Addendum No. 2**Issued: March 24, 2025**

Project Name: Reading School District
13th & Union Elementary Renovations
CHA Project No. 093251

WINDOW AND DOOR REPLACEMENT FOR
13TH AND UNION ELEMENTARY SCHOOL
READING SCHOOL DISTRICT
1600 NORTH 13TH STREET, READING, BERKS COUNTY, PA

MODIFICATION TO EXISTING WINDOW OPENING @ SOUTHERN MIDDLE SCHOOL - ALT. No. 4

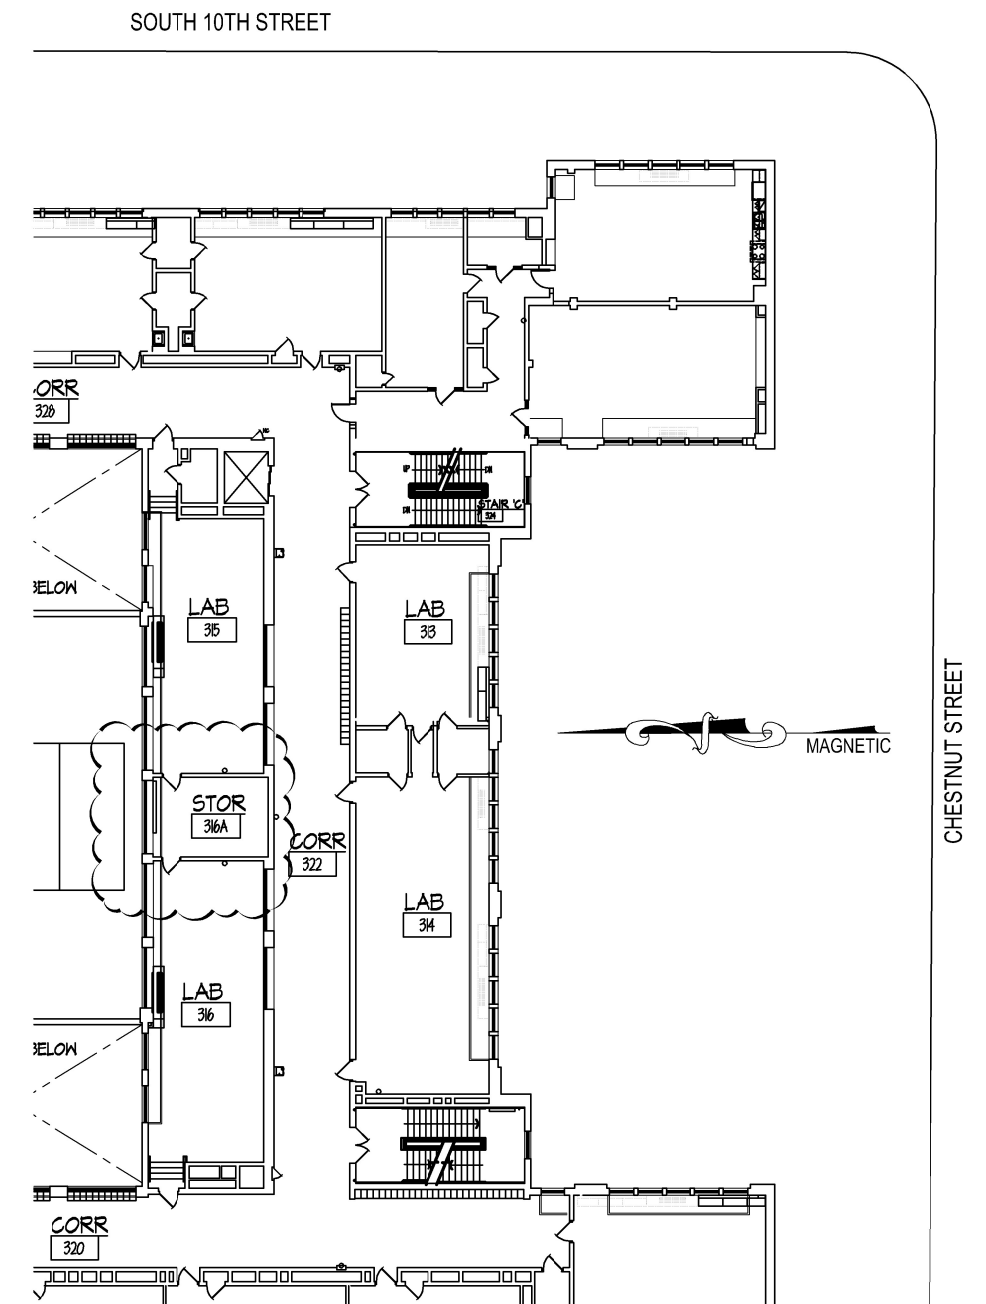
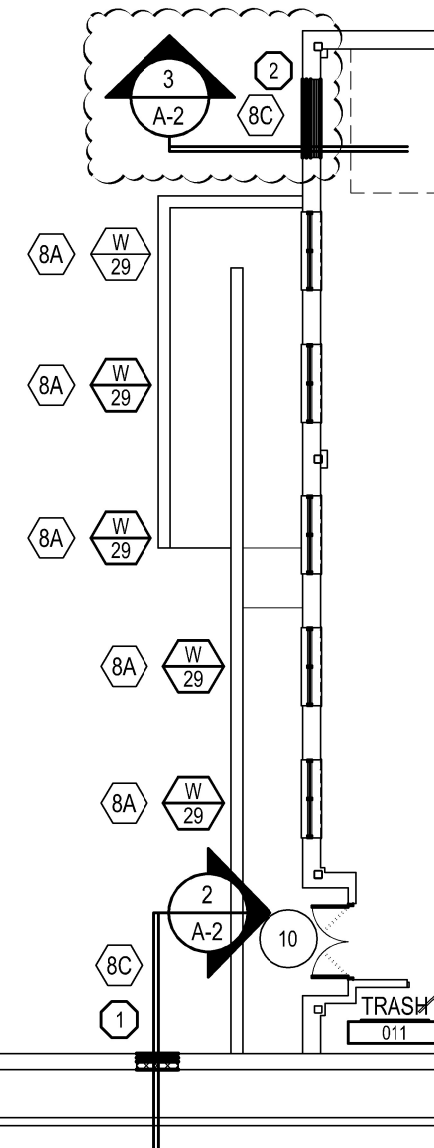
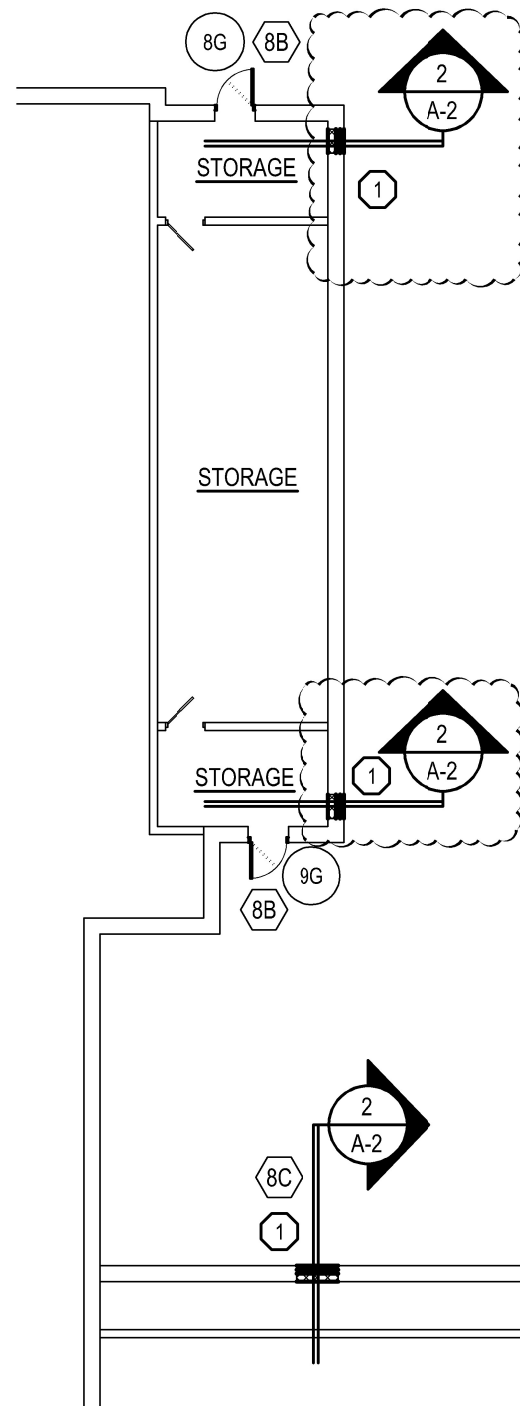
- 5.3 SKA-1, **ADD** the newly issued Sketch included as an attachment to this Addendum to address the Work at Southern Middle School.

EQUAL TO KAWNEER 451T GLASSVENT, OUTSWING CASEMENT. PROVIDE WITH MFR. STANDARD CAM LOCK WITH REMOVABLE CYLINDER AND SARGENT SIGNATURE 10-6300 CYLINDER IN ADDITION TO THOSE INDICATED IN HARDWARE SPECS.

METAL PANEL INFILL ON COLD FORMED METAL FRAMING @ 16" O.C. REFER TO DETAILS ON A-7

NEW LOUVER TO MATCH EXISTING SIZE, FUNCTION AND FREE AREA

EXISTING ANODIZED BRAKE METAL TO BE REPLACED TO MATCH NEW WINDOW (SEE PHOTO ABOVE)

CLARIFICATION OF RENOVATION NOTES

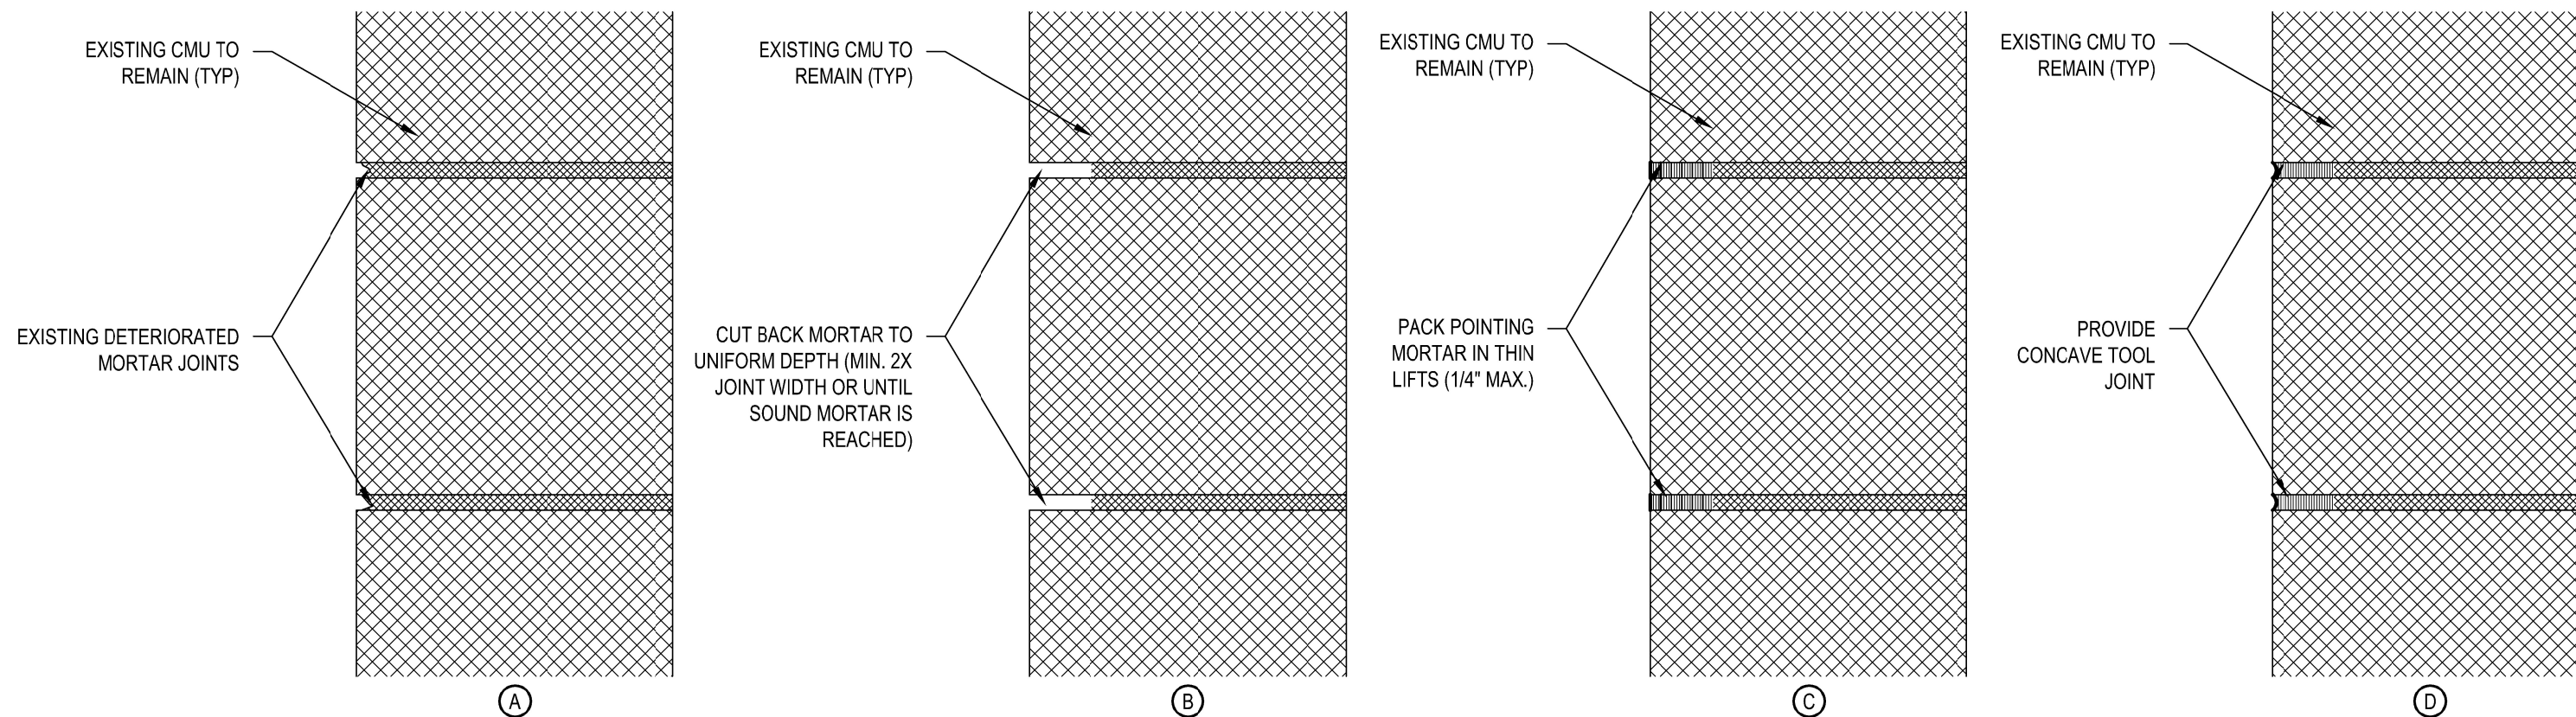
- 5.4 Drawing A-1, **ADD** the newly issued Sketch, SKA-2 included as an attachment to this Addendum to clarify the Renovation Notes.

- 6.2 **Question:** *Sheet A-1, basement floor plan, the windows that get infilled have an octagonal 1. The legend says that is a renovation note. Does it mean something else?*

Answer: We are clarifying this information in Addendum No. 2 with a sketch to provide information that was accidentally omitted from the drawings.

- ① INFILL WALL OPENING - REFER TO DETAIL 2/A-2
- ② INFILL WALL OPENING - REFER TO DETAIL 3/A-2

1. PRIOR TO APPLYING PAINT ALL EXISTING WALLS SHALL BE SPACKLED AND REPAIRED AS REQUIRED IN ACCORDANCE WITH MPI - MAINTENANCE AND REPAINTING MANUAL.
2. ANY OPENINGS IN CMU WALLS INDICATED TO BE INFILLED SHALL BE PATCHED BY G.C., TOOTHING NEW CMU/BRICK INTO EXISTING CMU/BRICK. MATCH EXISTING CMU/BRICK SIZE, COURSING, ETC.
